Notice of Intent - Plug and Abandonment

Operator: Simcoe LLC
Lease: NMSF078209B
Agreement: NMNM78391C
Well(s): Gallegos Canyon Unit 180E, API # 30-045-24869
Location: SESW Sec 28 T29N R12W (San Juan County, NM)
Sundry Notice ID#: 2834437

GCU Com H 180E

Plug and Abandon Procedure

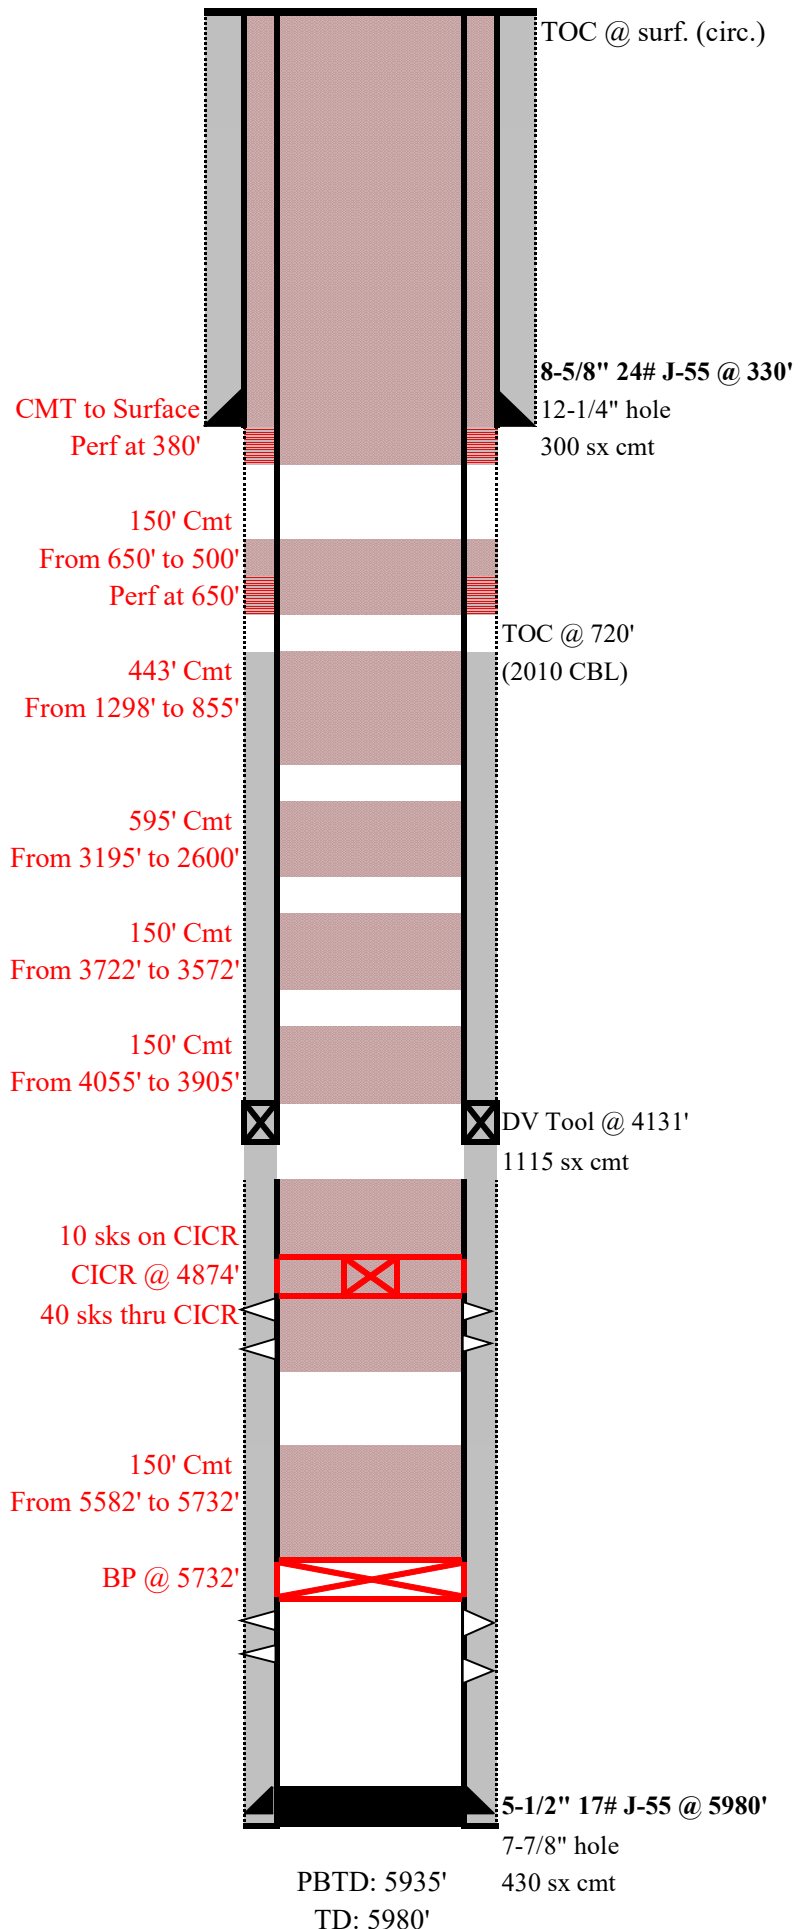
3. **The following modifications to your plugging program are made:**
 - a. Adjust Plug 5 (Menfee/Cliffhouse) to cover at a minimum the BLM geologist's Cliff House formation top pick @ 2763'. Plug should cover 2813' up to 2663'.

- i. Covering the Menefee is not required. BLM typically only requires a plug covering the top of Mesa Verde Group at the Cliff House formation top. If Simcoe wishes to cover the Menefee, adjust plug to cover 2945' up to 2663'.

- b. Add a Chacra plug with the BOC at 2278' and TOC at 2128' to account for the BLM geologists' pick for the Chacra at 2228'.
 - c. Plug 4 covering the Point Lookout is not required. BLM typically only requires a plug covering Mesa Verde Group top at Cliffhouse formation top. If Simcoe wishes to cover the Point Lookout, the originally proposed plug covering 3722' up to 3572' is appropriate.

- d. BLM requests an explanation for the purpose of inside/outside plug from 650' to 500'. This plug does not cover any additional formations and appears to be unnecessary.

-Modify the Menefee plug BOC to 2945' and the TOC to 2663' to account for the BLM geologists' picks for the Menefee and Cliff House and cover both formations.

-Add a Chacra plug with the BOC at 2278' and the TOC at 2128' to account for the BLM geologists' pick for the Chacra and a request from the NM OCD.

-The BLM requests an explanation for the purpose of the inside/outside plug from 650' to 500'.

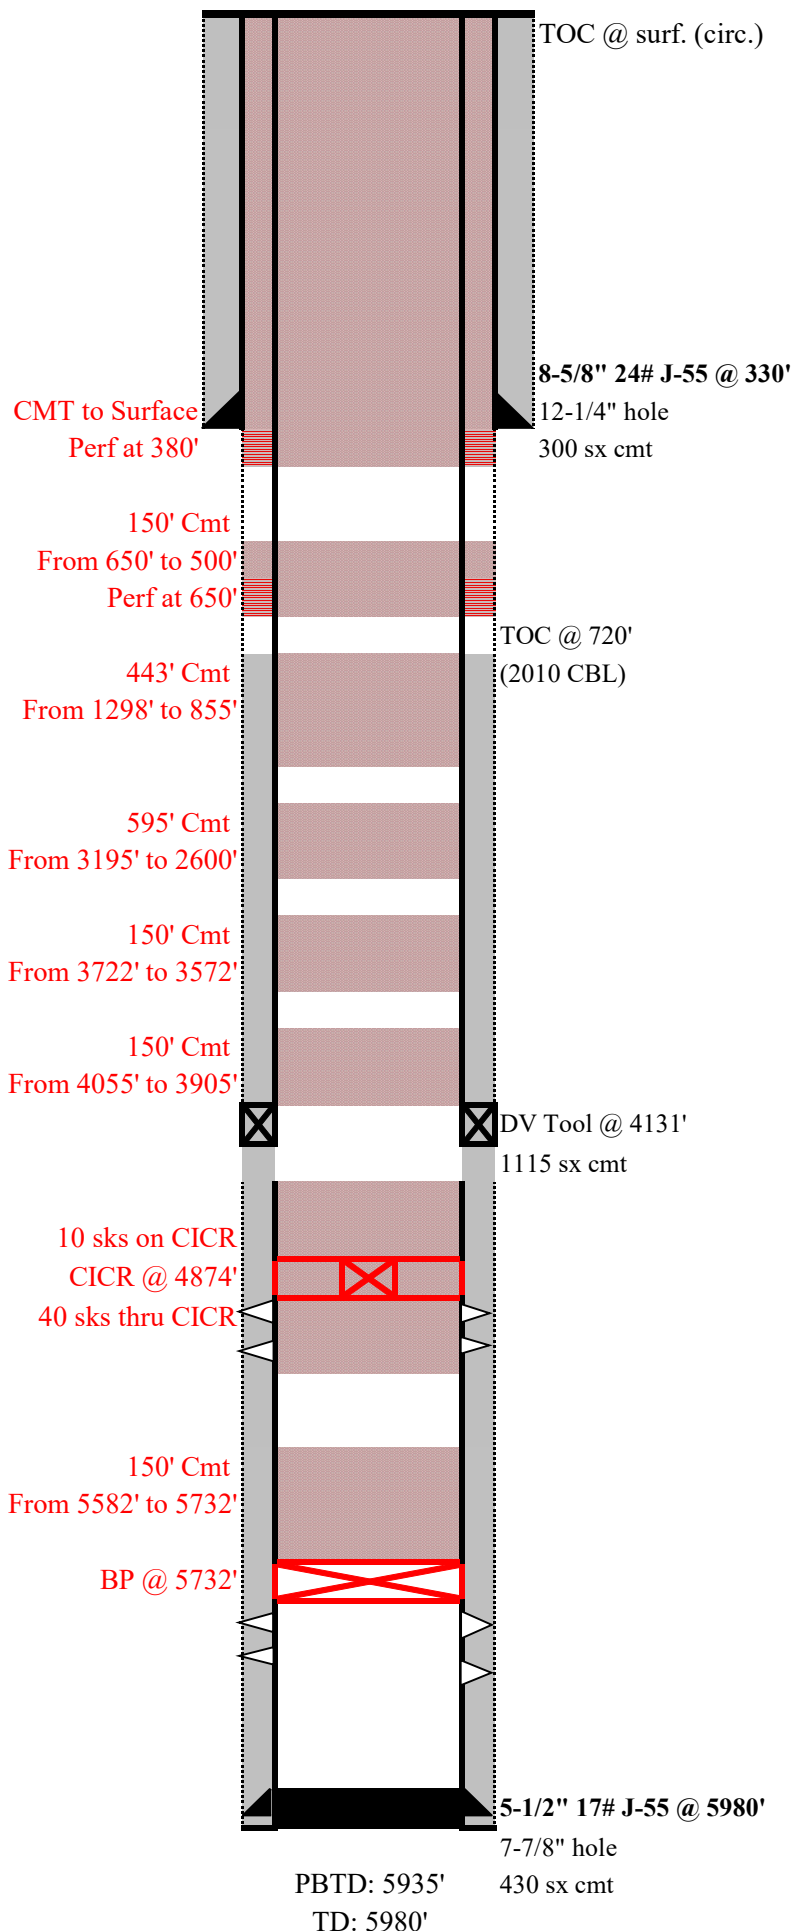
3. **The following modifications to your plugging program are made:**
 - a. Adjust Plug 5 (Menfee/Cliffhouse) to cover at a minimum the BLM geologist's Cliff House formation top pick @ 2763'. Plug should cover 2813' up to 2663'.

- b. Add a Chacra plug with the BOC at 2278' and TOC at 2128' to account for the BLM geologists' pick for the Chacra at 2228'.
 - c. Plug 4 covering the Point Lookout is not required. BLM typically only requires a plug covering Mesa Verde Group top at Cliffhouse formation top. If Simcoe wishes to cover the Point Lookout, the originally proposed plug covering 3722' up to 3572' is appropriate.

- d. BLM requests an explanation for the purpose of inside/outside plug from 650' to 500'. This plug does not cover any additional formations and appears to be unnecessary.

- Vertical wellbore - all fm. tops are TVD.
- The Dakota and Gallup plugs are acceptable.
- The Mancos plug is acceptable.
- The Pt. Lookout plug is acceptable.
- Modify the Menefee plug BOC to 2945' and the TOC to 2663' to account for the BLM geologists' picks for the Menefee and Cliff House and cover both formations.
- Add a Chacra plug with the BOC at 2278' and the TOC at 2128' to account for the BLM geologists' pick for the Chacra and a request from the NM OCD.
- The Pictured Cliffs/Fruitland plug is acceptable.
- The BLM requests an explanation for the purpose of the inside/outside plug from 650' to 500'.
- The Surface plug is acceptable.
